LODI UNIFIED SCHOOL DISTRICT

**Lunch Shelter Project
at
Morada Middle School
Project Number: 0944-8244
DSA #:02-118353
and
Heritage Elementary School
Project Number: 0916-8216
DSA # 02-118354**

ADDENDUM NO. 1

October 21, 2021

**LUNCH SHELTER -
ENLARGED SITE PLAN
AND SECTION**

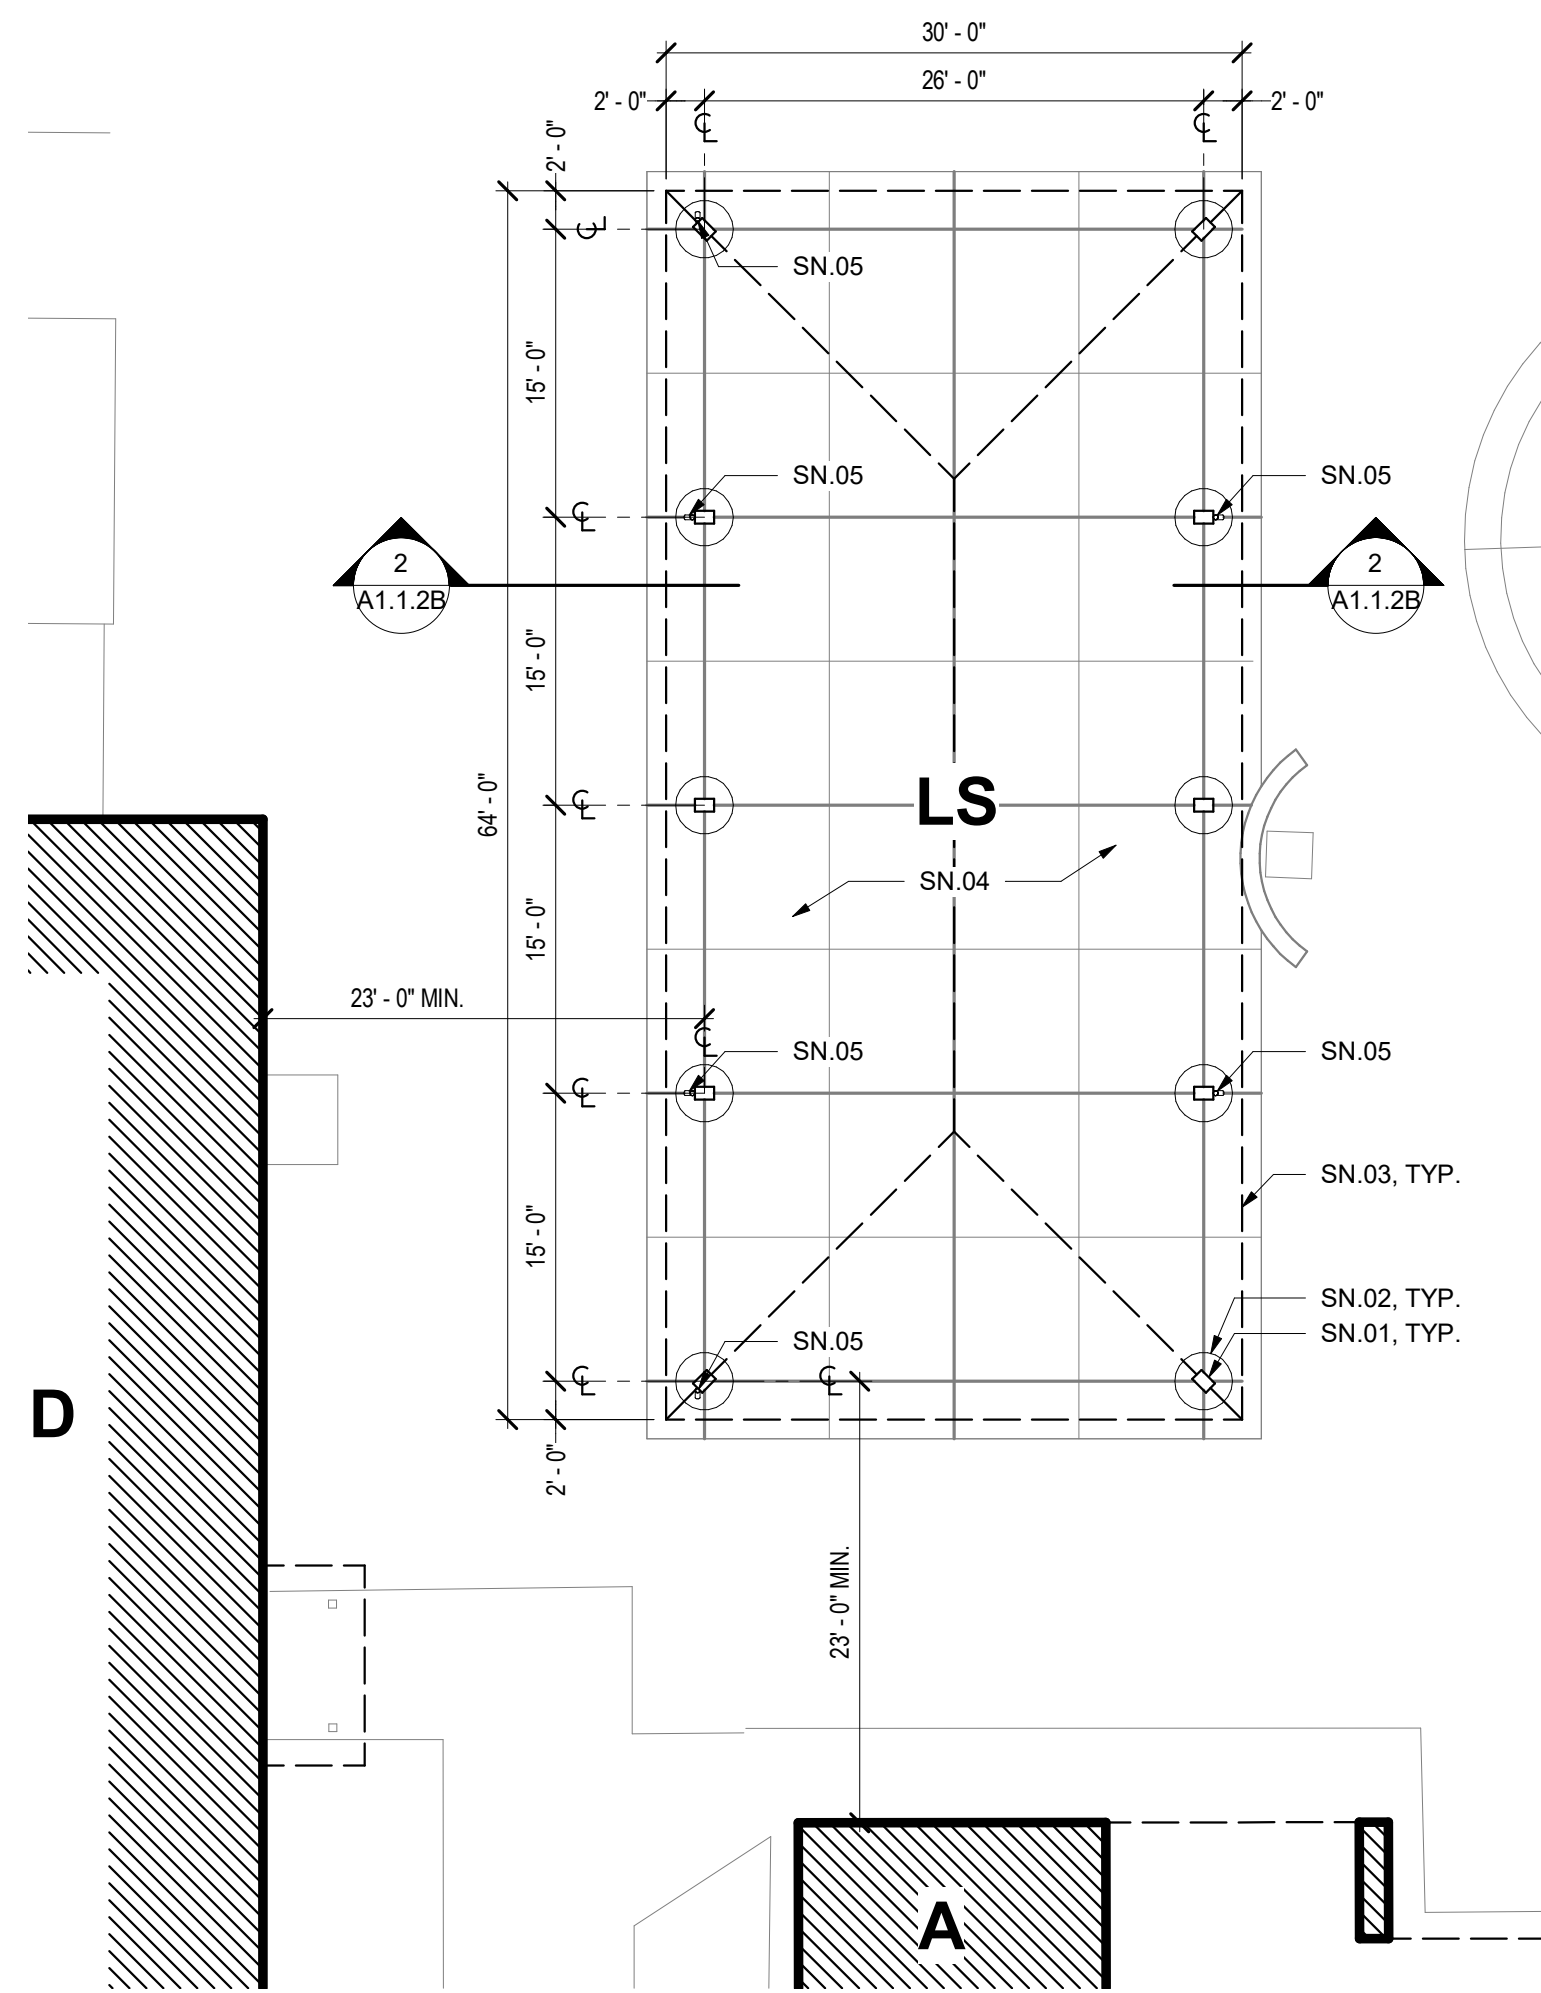
- 1.7 Sheet A1.1.0B, Site Plan and Code Information, Sheet Notes: REVISE SN.11 to read, "Existing 4'-0" x 7'-0" chain link gate per DSA application #02-118112."
- 1.8 Sheet A1.1.2B, Lunch Shelter – Enlarged Site Plan and Section: REVISE per the attached AD1.01.
- 1.9 Sheet A1.1.2C, Lunch Shelter – Enlarged Site Plan and Section: REVISE per the attached AD1.02.
- 1.10 Sheet A2.1.1C, Enlarged Floor Plans: REVISE per the attached AD1.03.
